CM CLARIFICATION #004

PROJECT: CNE Tahlequah Casino

ADDENDUM # 001

Tahlequah Casino Addendum #01 summary

SHEET NUMBER: S3.1

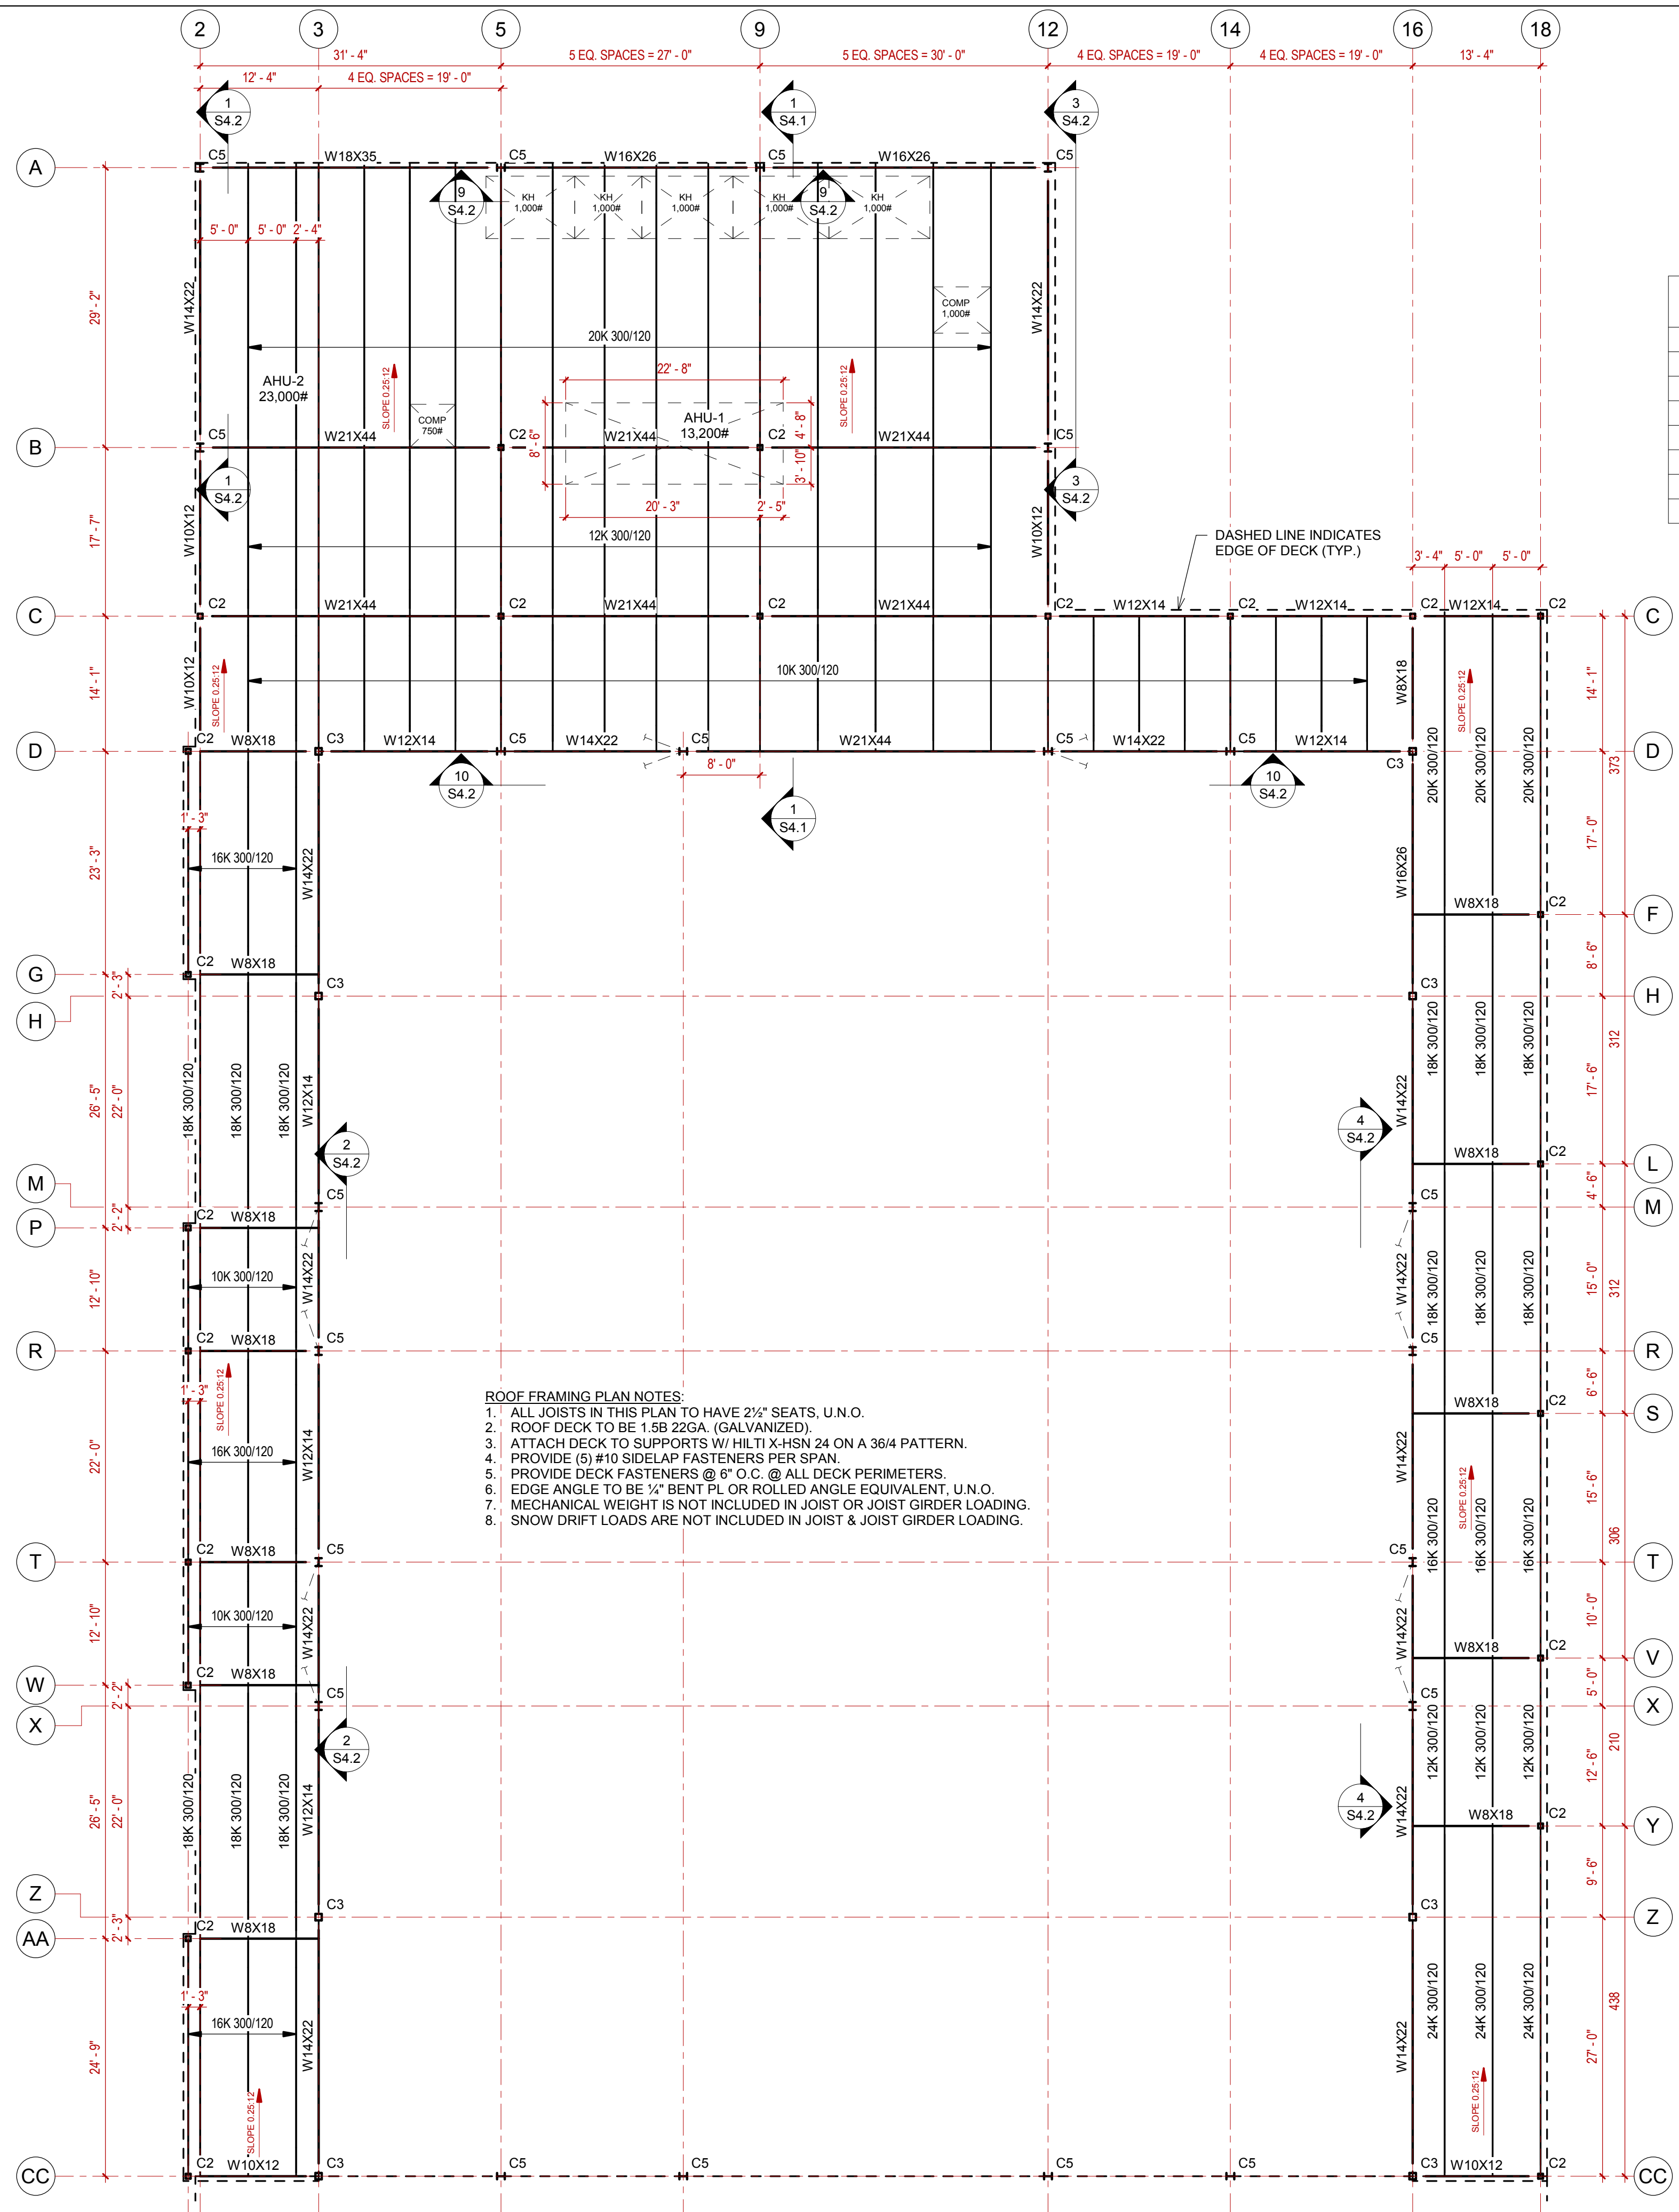
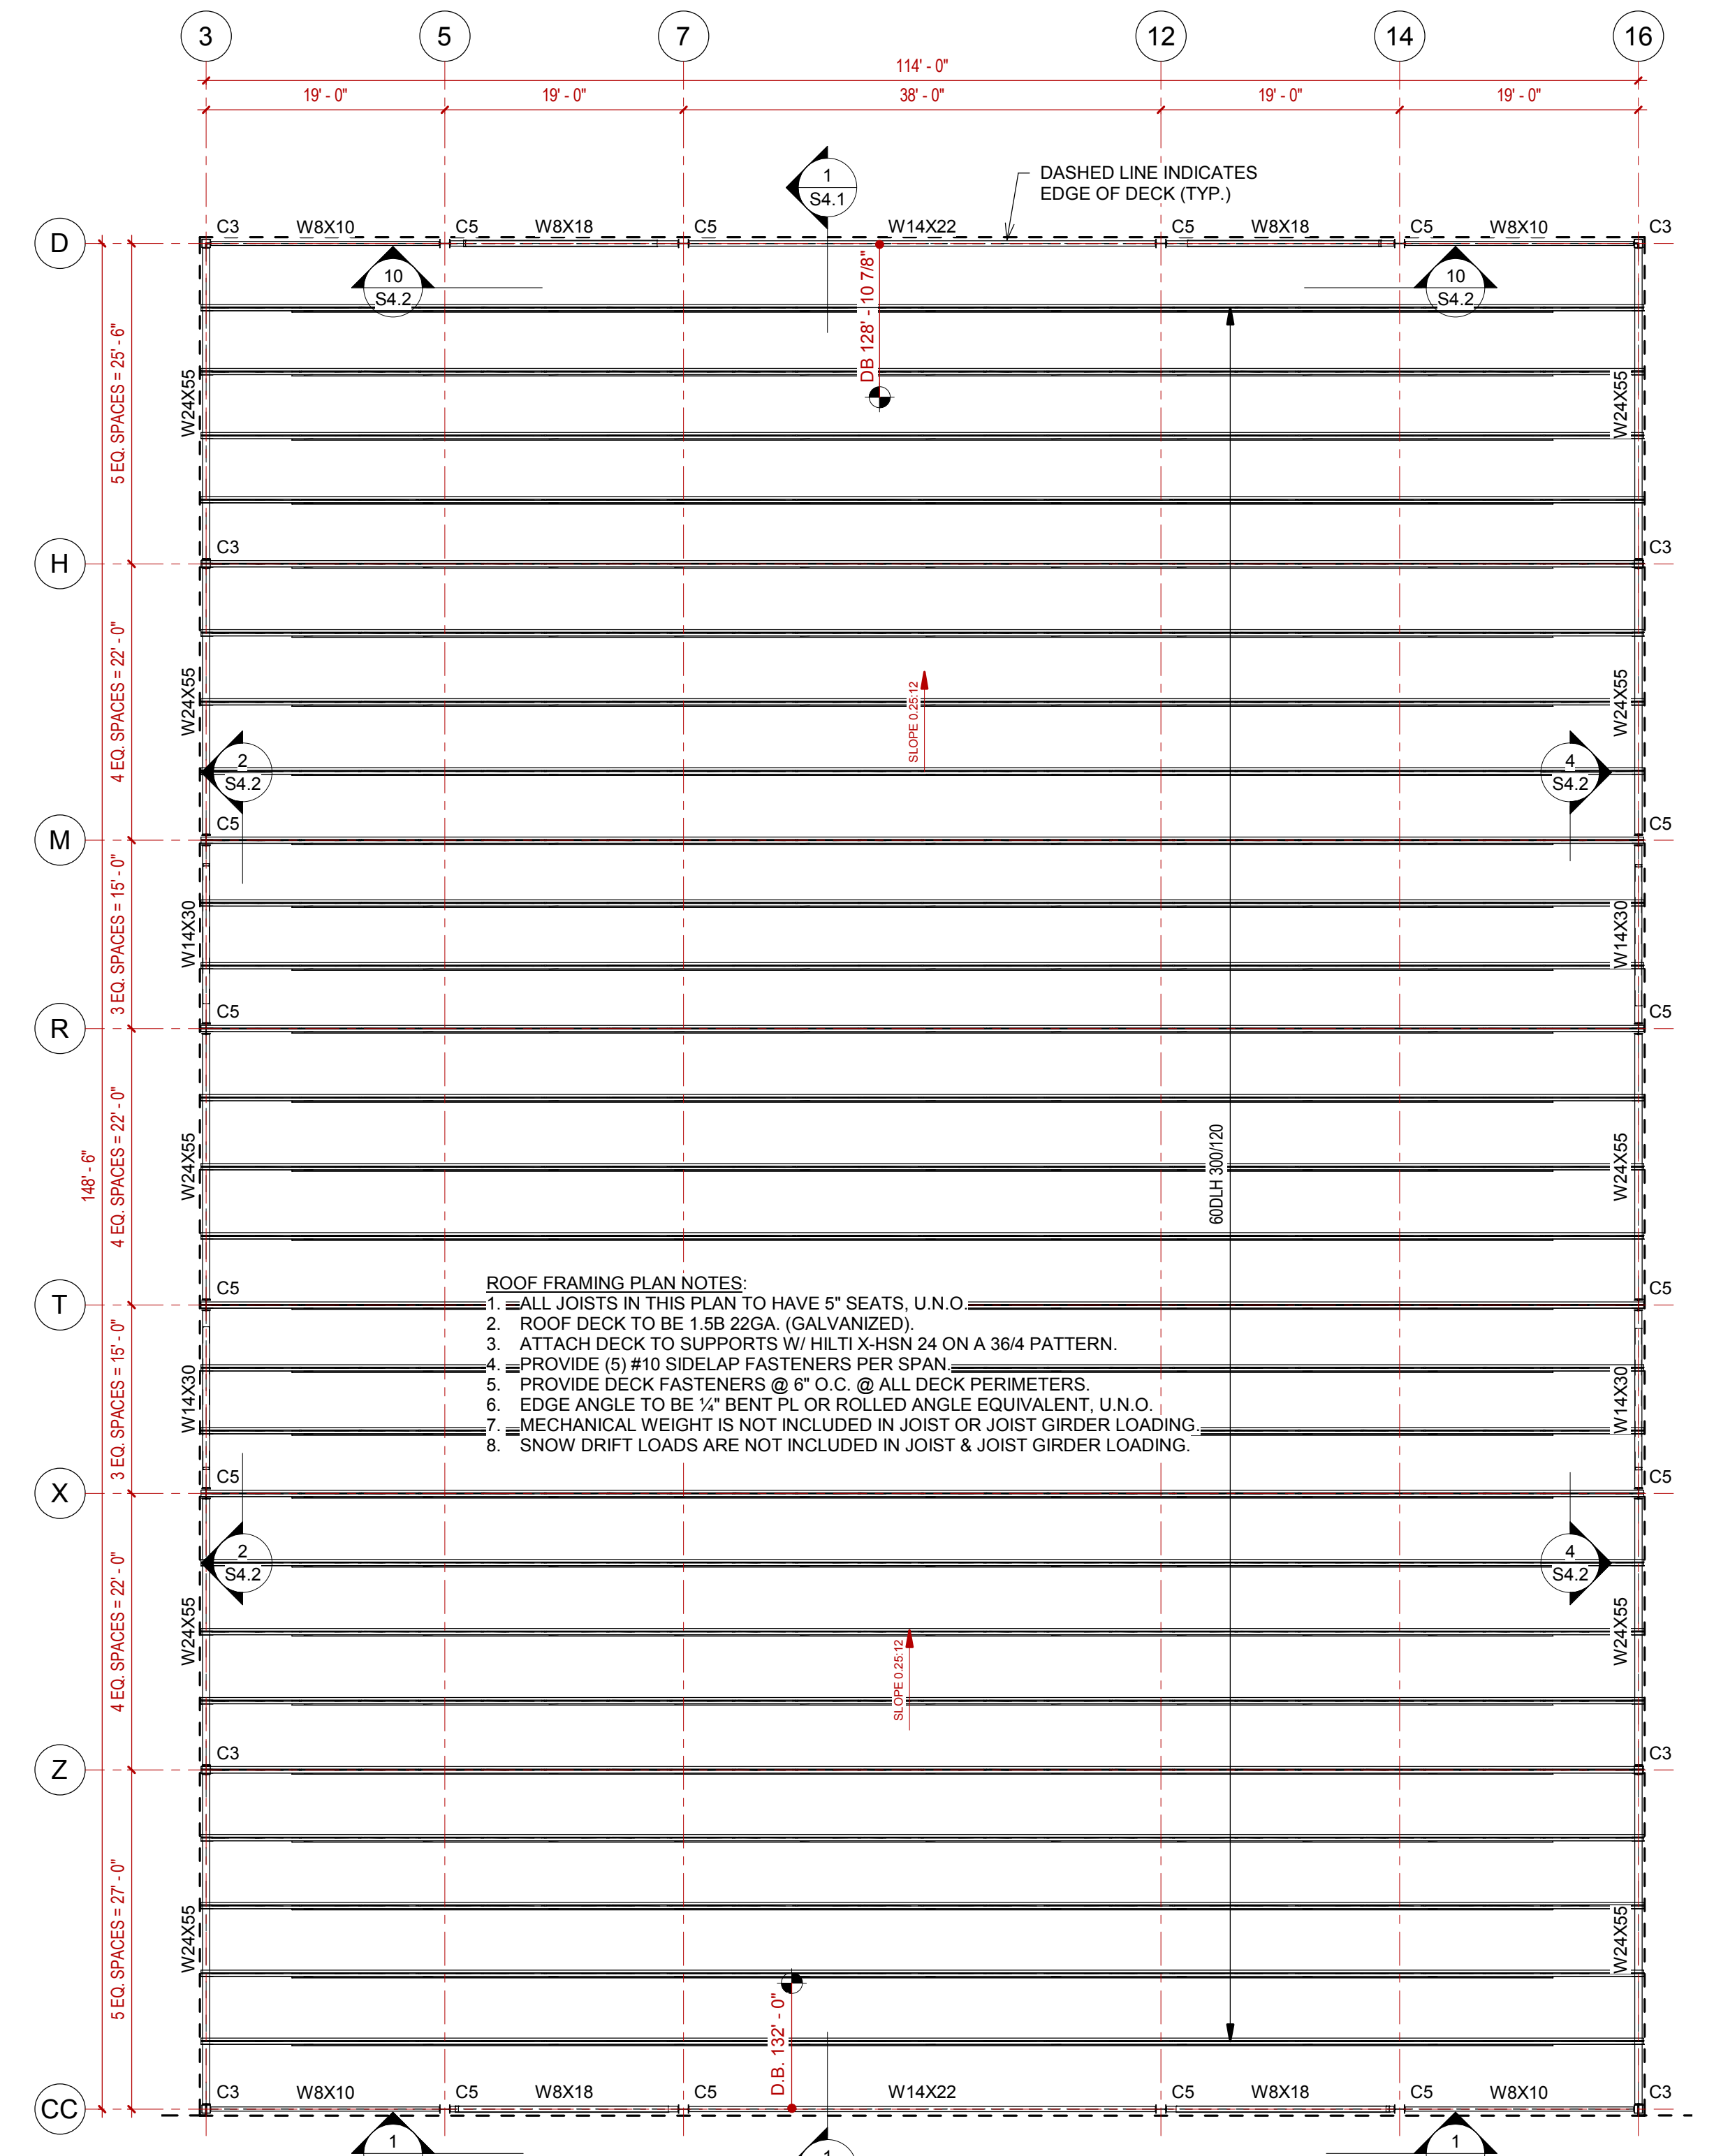
S1.5	Added sheet S1.5
S1.6	Added sheet S1.6
S1.7	Added sheet S1.7
S2.1	<ul style="list-style-type: none"> • Added enlarged stage pit plan and sections. • Added pit for dock levelers.
S3.1	<ul style="list-style-type: none"> • Revised roof deck to galvanize. • Revised column sizes.
S3.2	<ul style="list-style-type: none"> • Moved brace elevation from Y/BB-19 to U/BB-21 • Moved frame line 'DD' 1" east • Revised roof deck to galvanize. • Removed column @ U-19 & U-27.

<ul style="list-style-type: none"> • Removed joist girders on gridline 'U' • Revised joist framing. Revised joist girder loadings
S3.3	<ul style="list-style-type: none"> • Removed brace elevation 42/44-E • Removed column @ E-44 • Revised joist framing. Revised Joist girder loadings
S3.4	Revised detail 7/S3.4
S4.1	Revised section 2/S4.1
S4.2	<ul style="list-style-type: none"> • Revised column size in framing elevation. • Revised brace sizes in framing elevations • Added detail callouts to framing elevations. • Frame elevation moved from grid '19' to '21' • Removed frame elevation @ grid 'E'
S4.3	<ul style="list-style-type: none"> • Revised column size in framing elevation. • Added detail callouts to framing elevations • Added braced frame details
S5.1	Added sheet S5.1
